ADDENDUM NO. 2

CITY OF PLATTSBURGH DOWNTOWN REVITALIZATION INITIATIVE ARTS PARK

SA PROJECT # 2018-039.10

November 13, 2020

C100

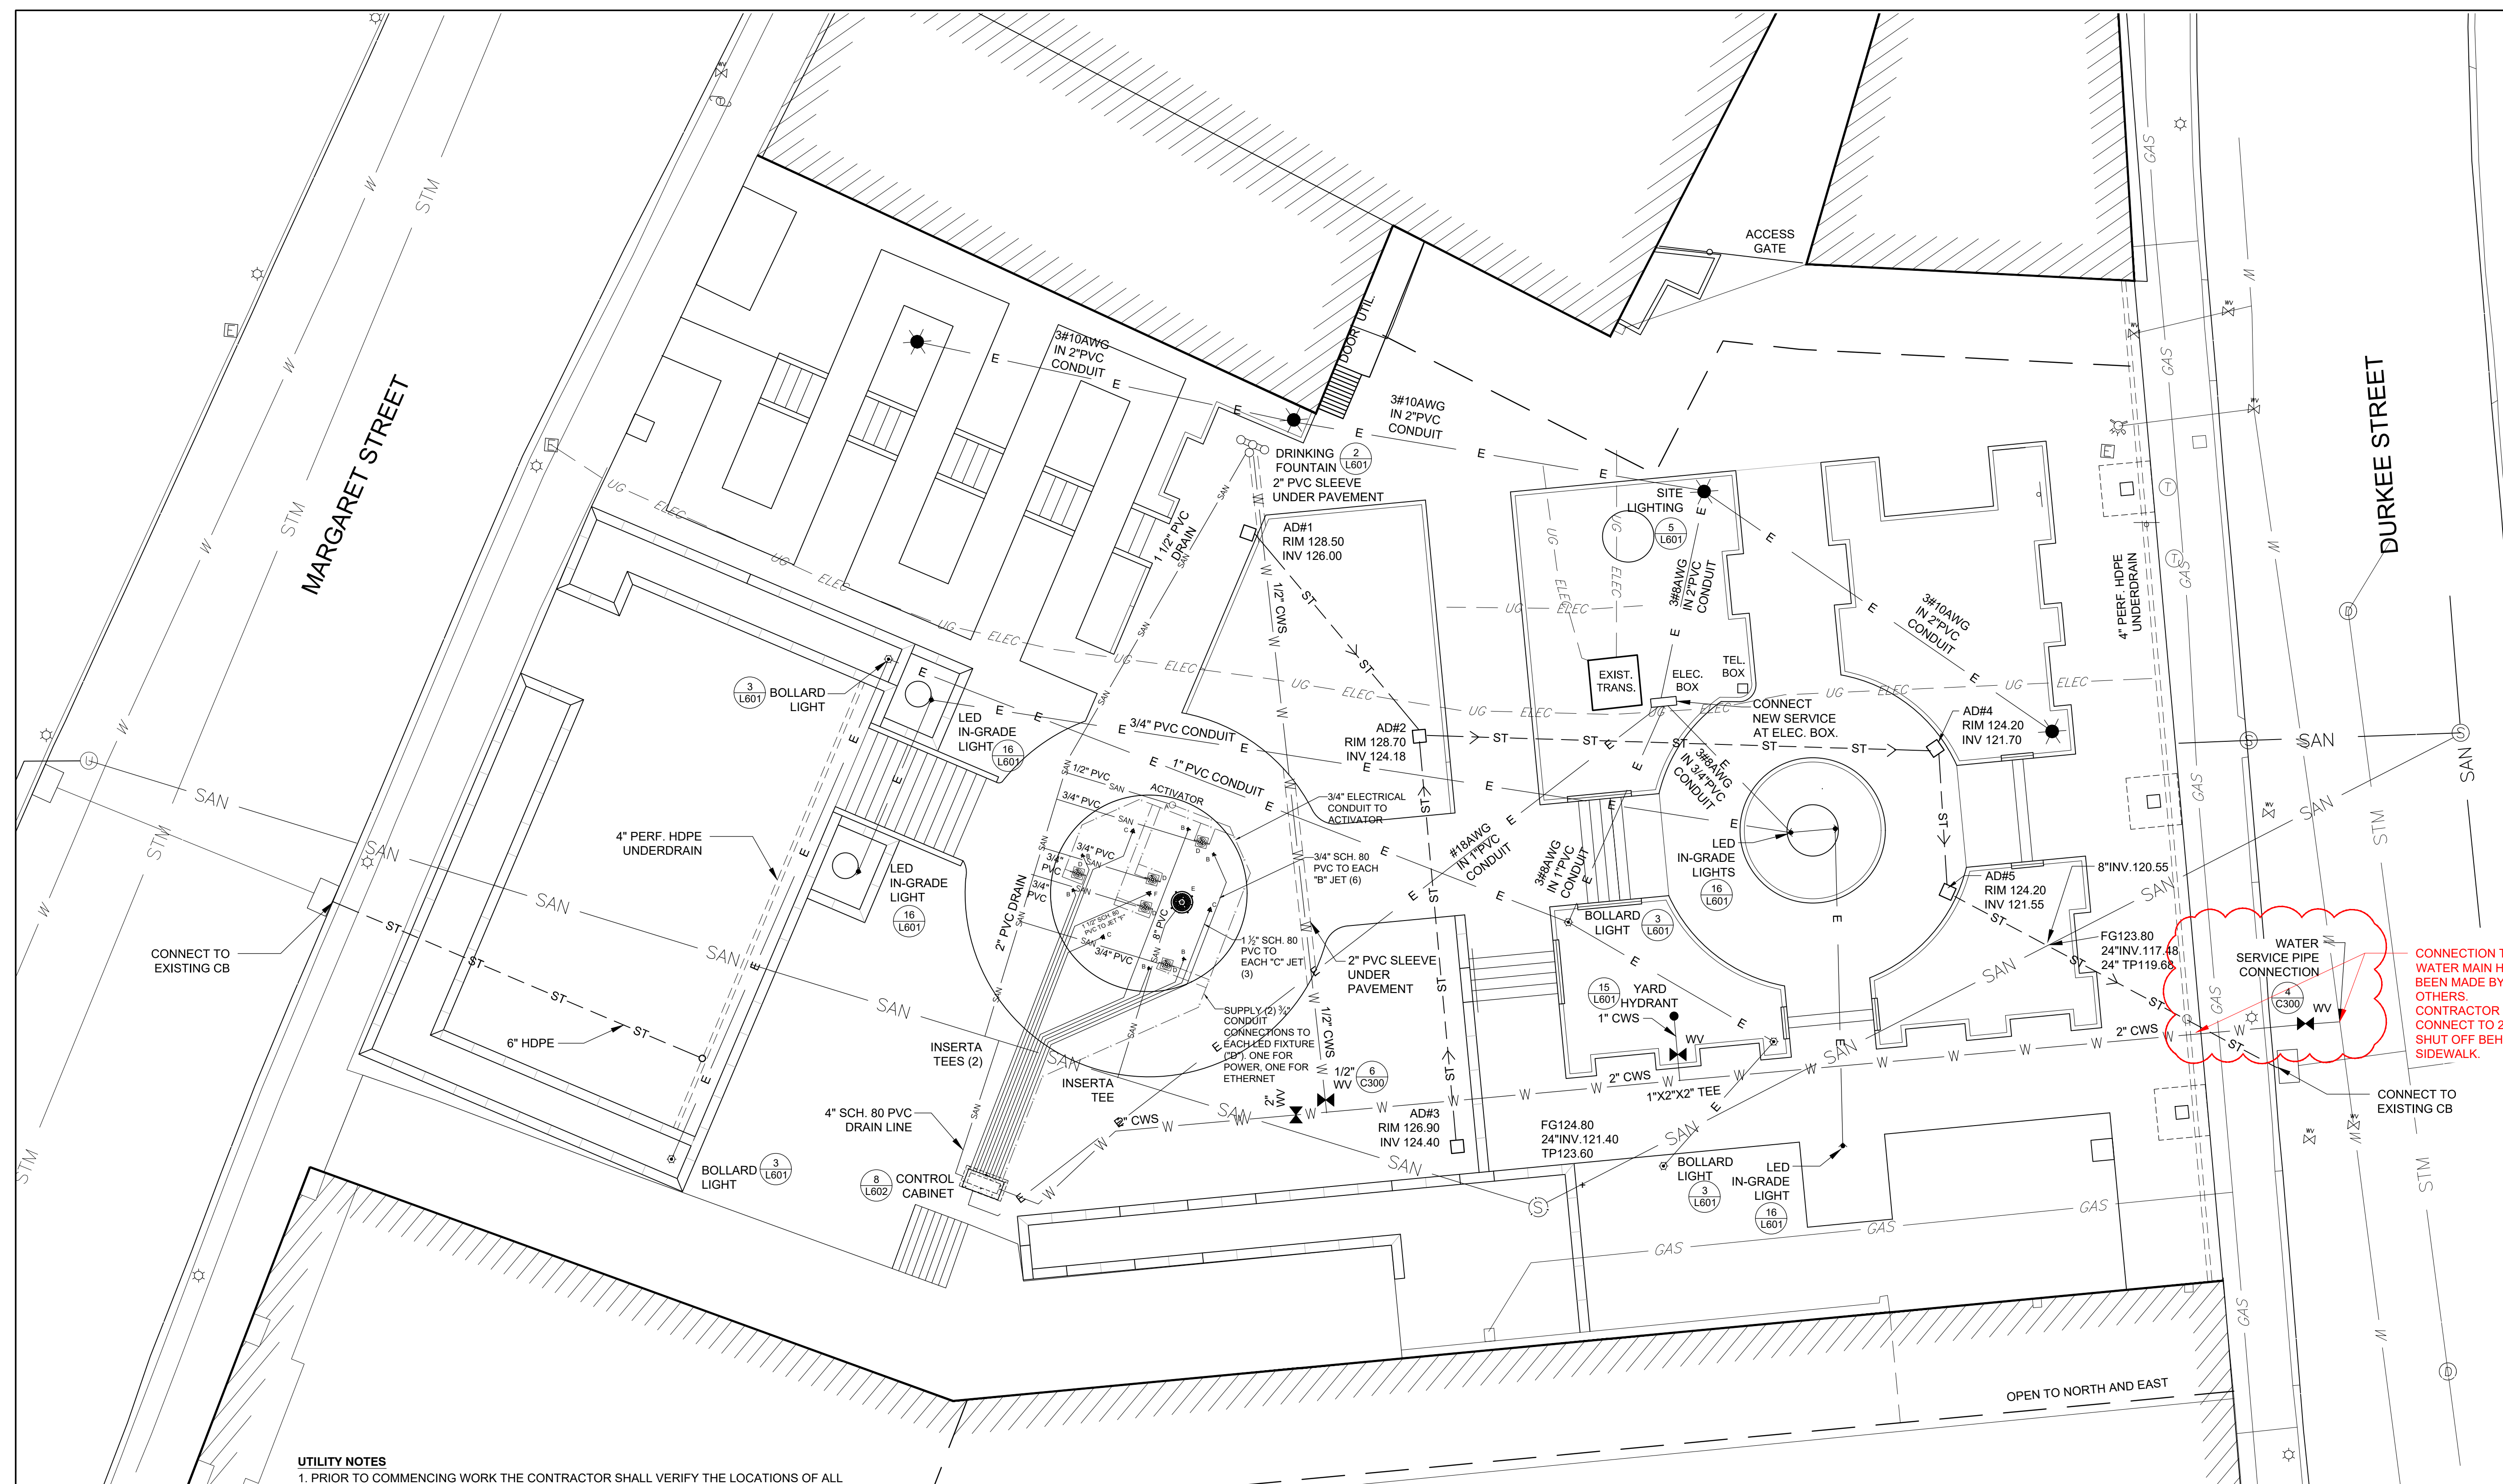
4. Re: C100: Vista LED in-grade lights have a max. ¾” conduit hub. C100 calls for 2” PVC conduits which will not fit.
Is it acceptable to provide ¾” PVC conduit for all LED in-grade lights?
Yes, provide ¾” PVC conduit for all LED in-grade lights.

5. Re: C100: Bollards lights will not fit two 2” PVC conduit stubs.
Is it acceptable to provide 1” PVC conduit for all bollard lights?
Yes, provide 1” PVC for all bollard lights.

6. Re: 13 1118 and C100: Per specifications, all electrical work for splash pad equipment is by the plumbing contract. Per C100 drawing, there is an electrical conduit feeding from splash pad cabinet to the existing pad-mounted service transformer. Which contract is responsible for this conduit?

Why is the conduit running back to the service transformer and not the existing electrical panel box?

What size conduit and wire is required to feed the splash pad cabinet?

All connections should be made to the electrical box. C100 has been revised.

Per 13 1118, 2.03 A.5.: Electrical wiring shall be #18 AWG with a 600V rating. Provide 1" PVC conduit.
